*Final*

**Uniform Federal Policy – Quality Assurance Project Plan for  
Remedial Action**

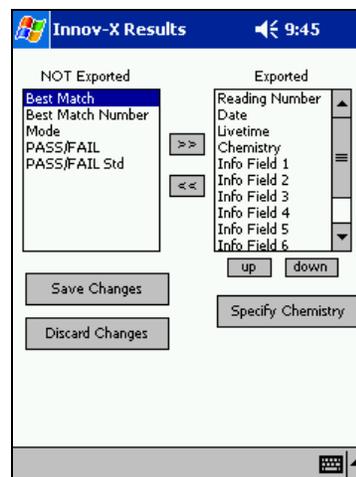
Exported field order can be changed by using the **Up/Down** buttons. Select a field and move it up or down as desired
